ADDENDUM 03

Community Crisis Center
Helix Project No.24001.00

Issue Date: 7.28.25

E131

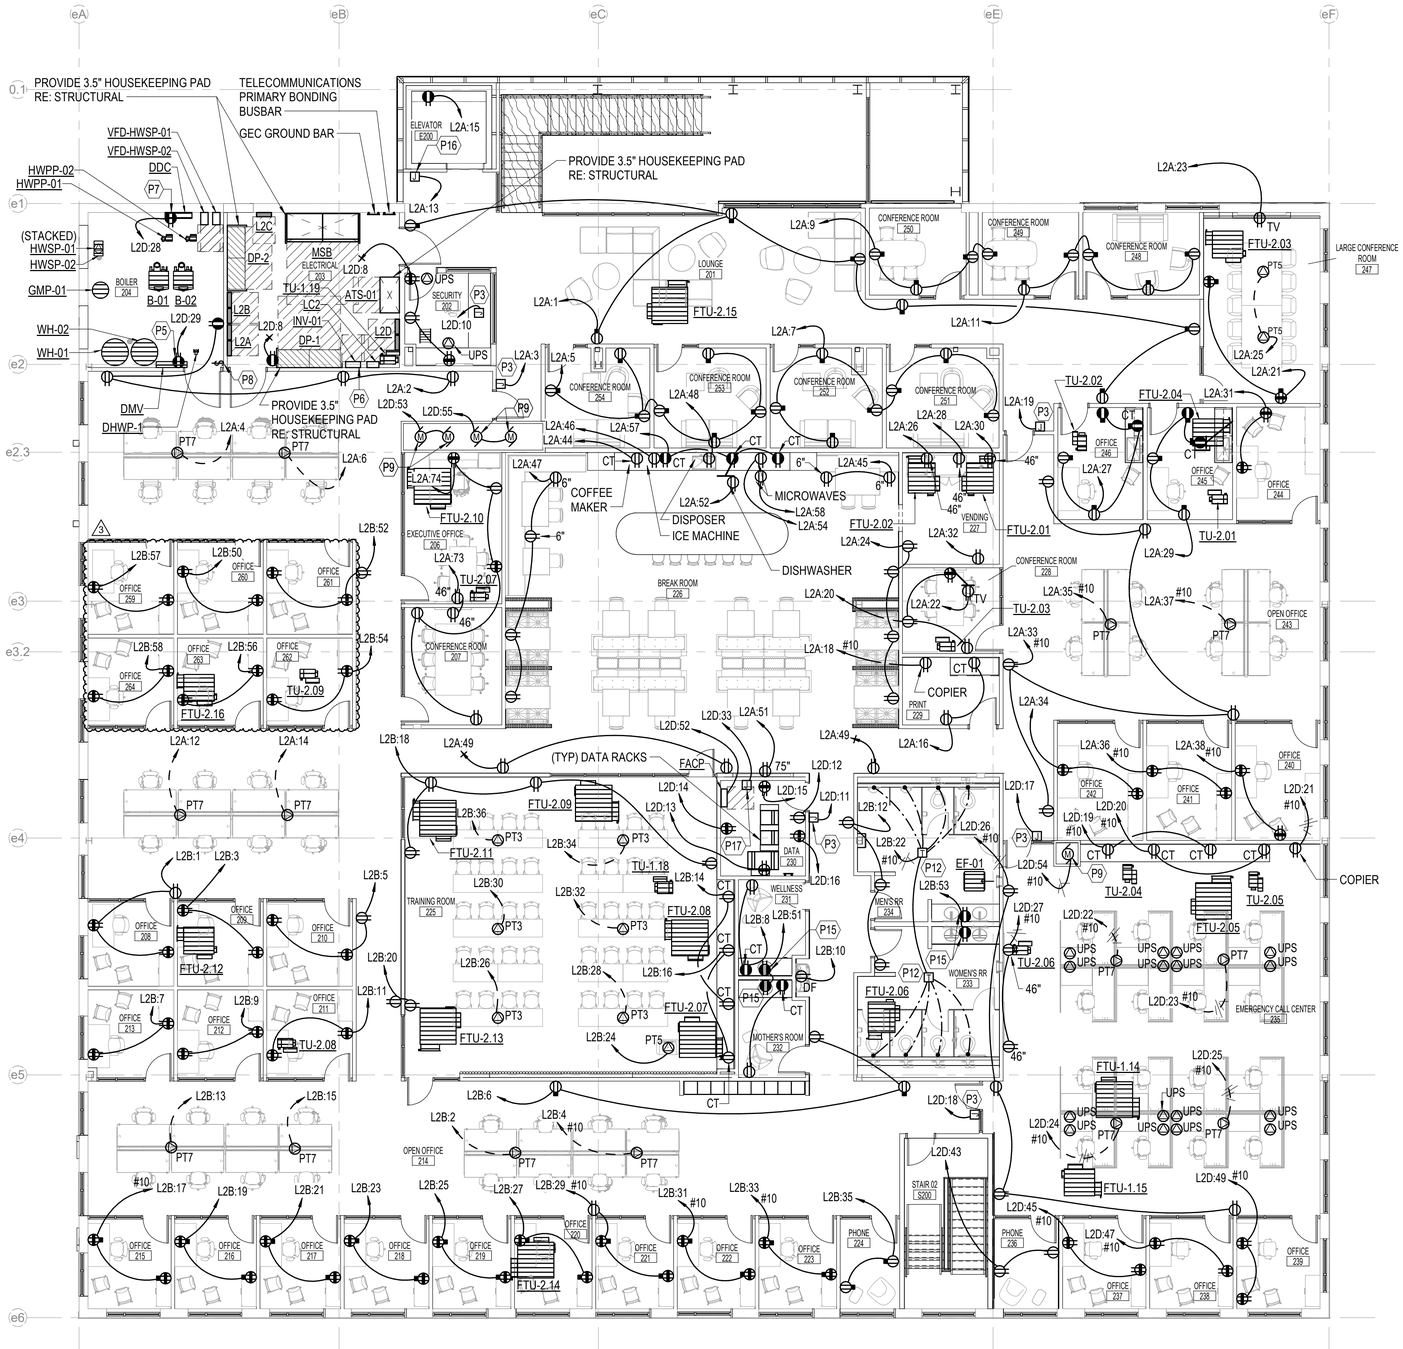
E131 – LEVEL 01 ELECTRICAL POWER FLOOR PLAN
1. **REVISE** layout for med storage room 159
2. **REVISE** layout for office 121

E132

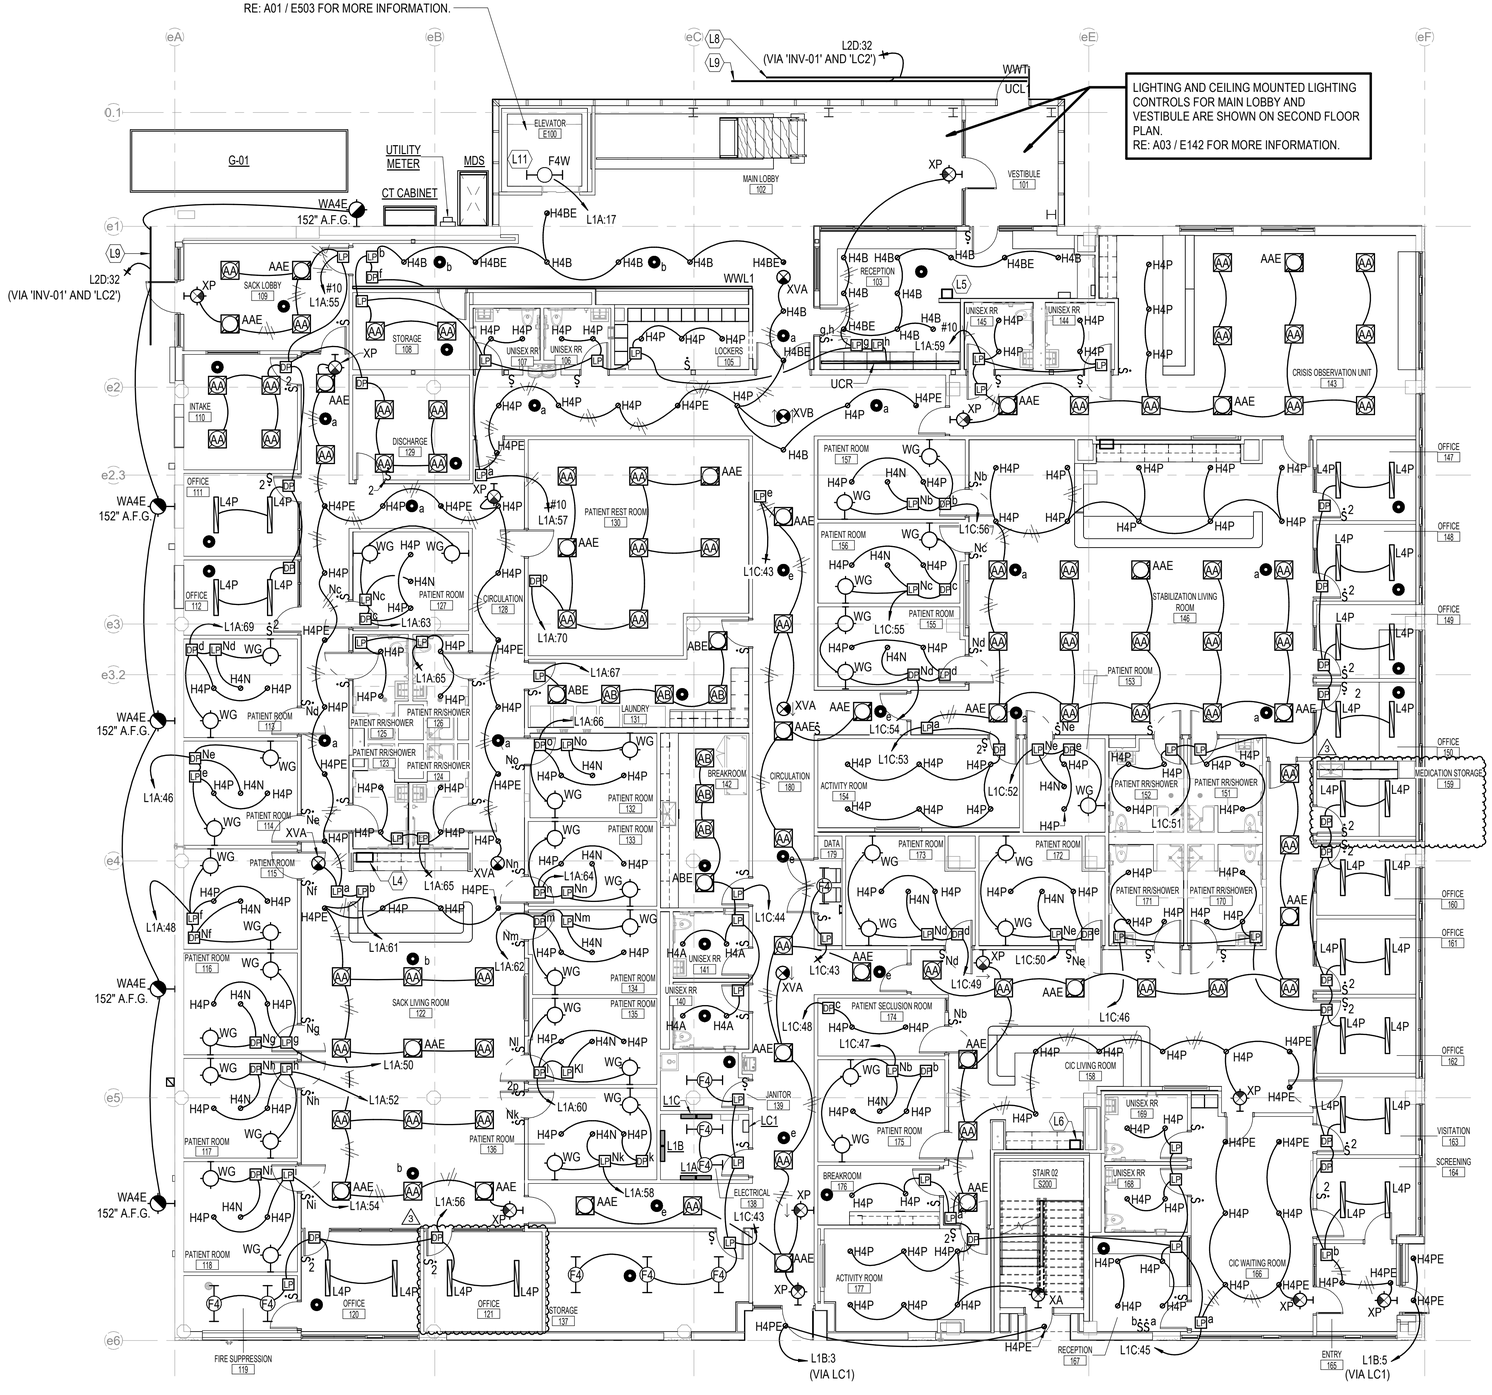
E132 – LEVEL 02 ELECTRICAL POWER FLOOR PLAN
1. **REVISE** layout for additional offices added, rooms 259-264.

E141

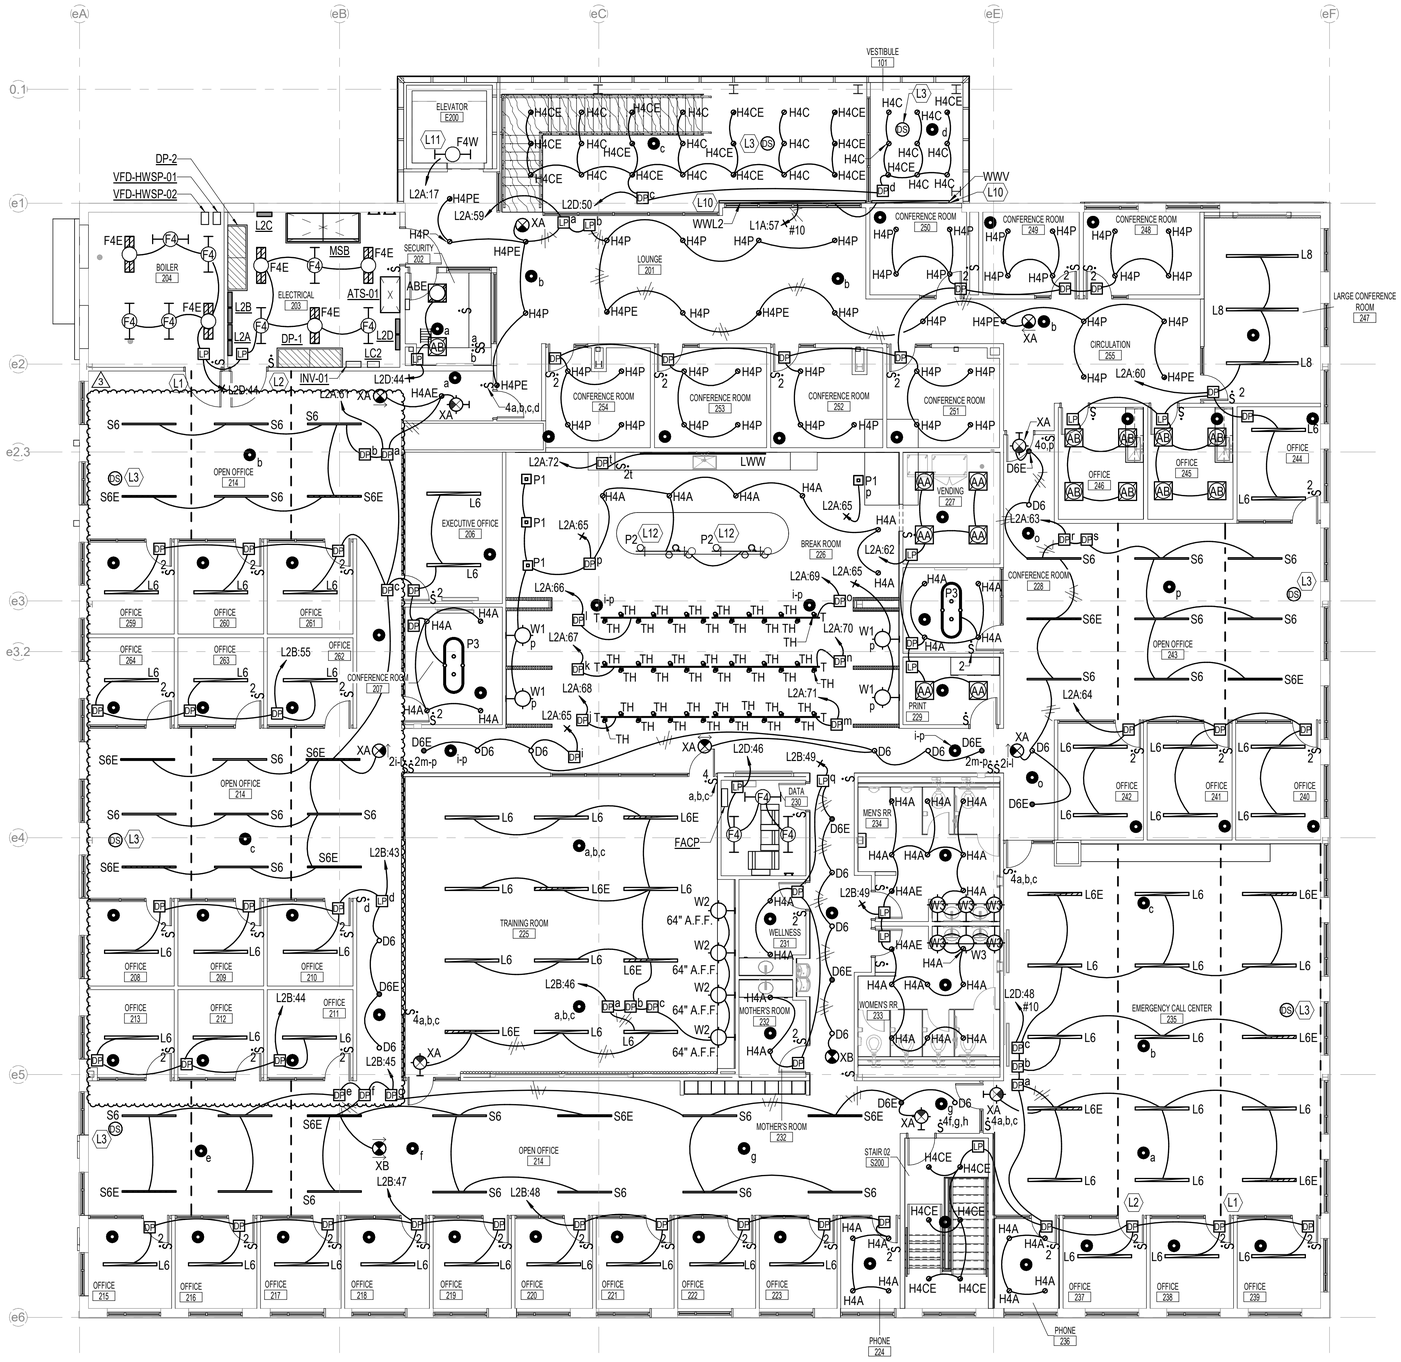
E141 – ELECTRICAL LIGHTING FLOOR PLAN
1. **REVISE** layout for med storage room 159
2. **REVISE** layout for office 121

T121

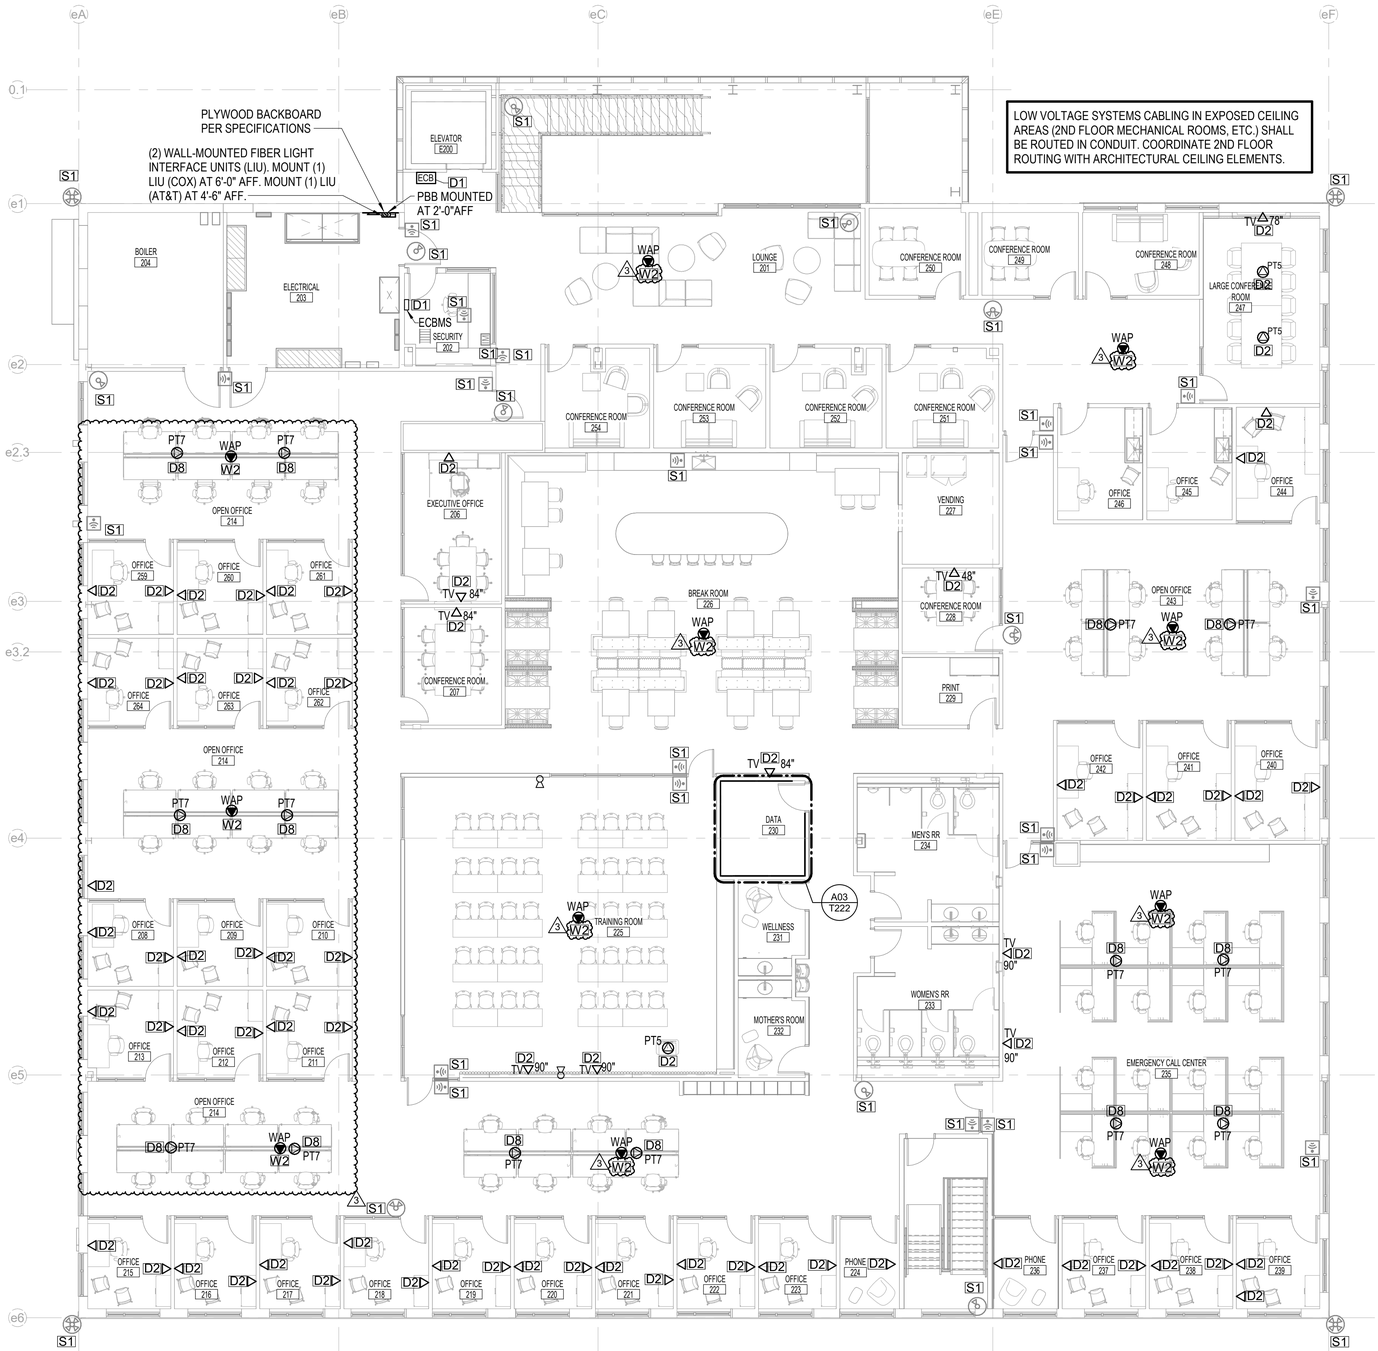
T121 – LEVEL 01 COMMUNICATIONS PLAN
1. **REVISE** office to Medication Storage 159
2. REVISE cable tags for WAPs
3. **ADD** data for Office 121

T132

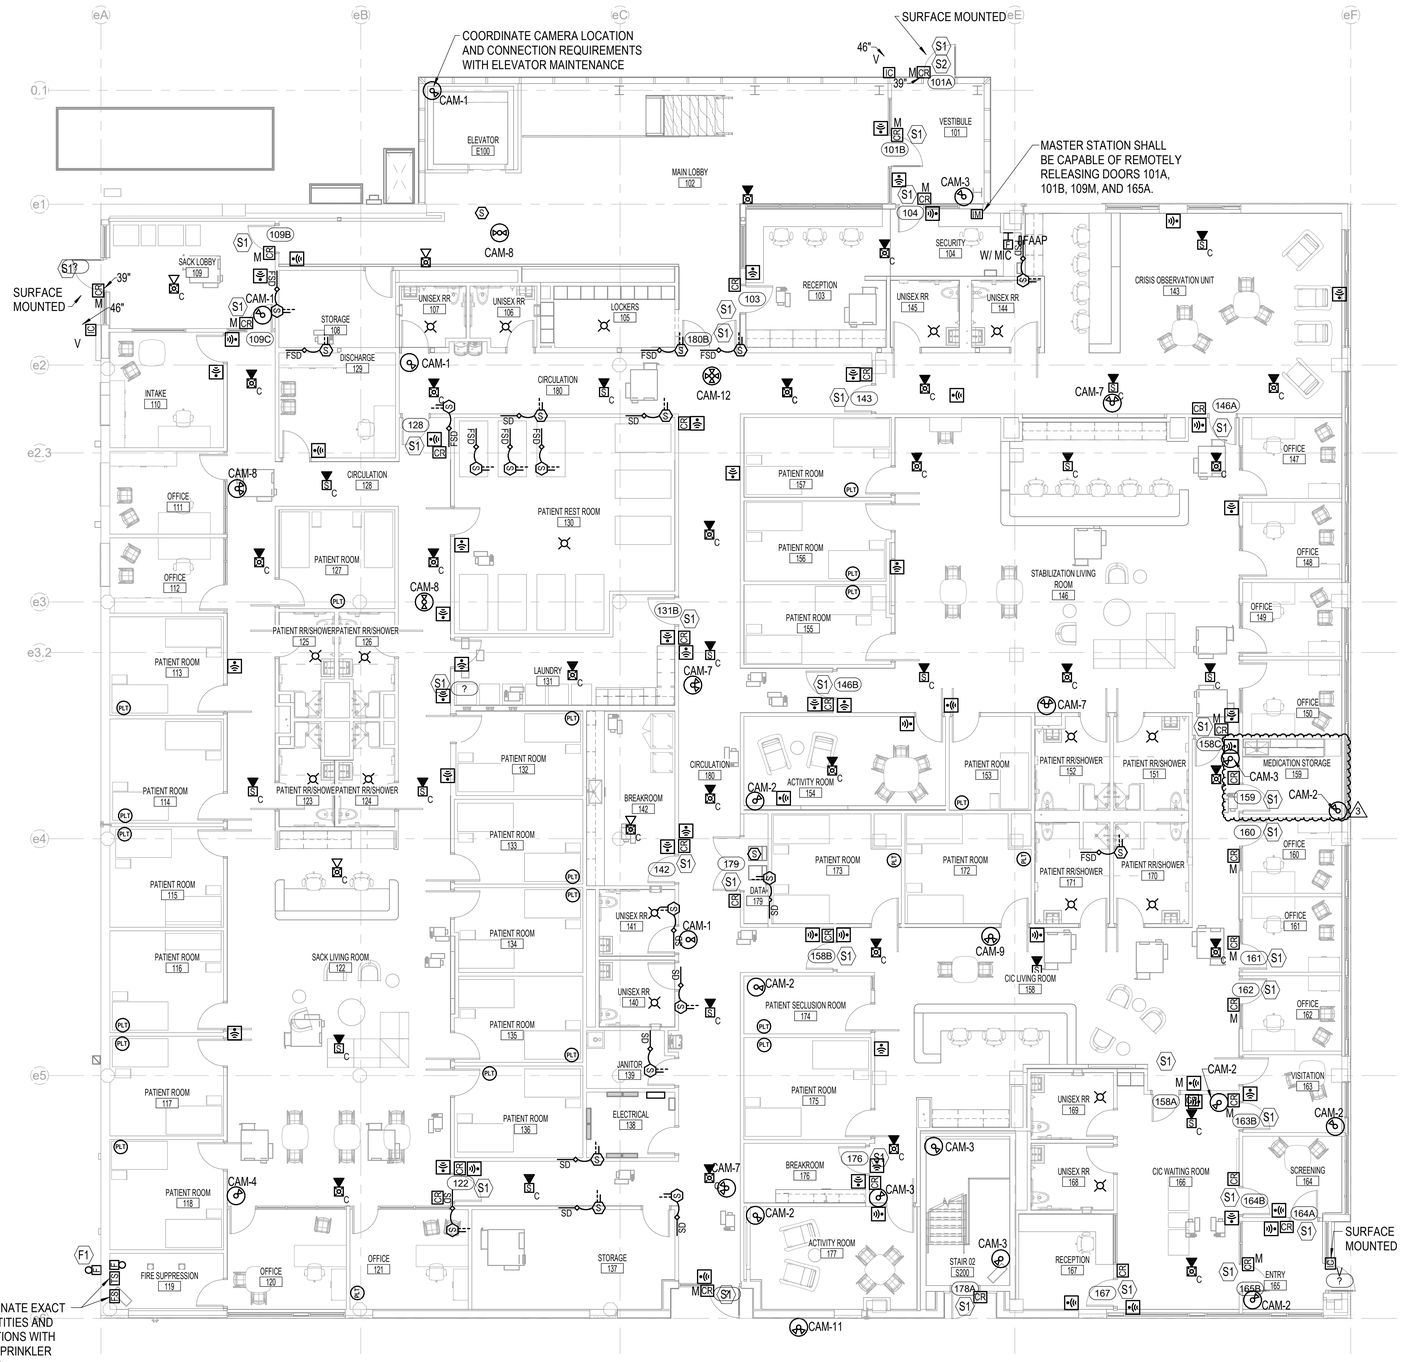
T132 – LEVEL 02 AUDIO-VISUAL PLAN
1. **REVISE** EM-01 layout for Zone A. Removed (6) EM-01 to accommodate revised floor plan.
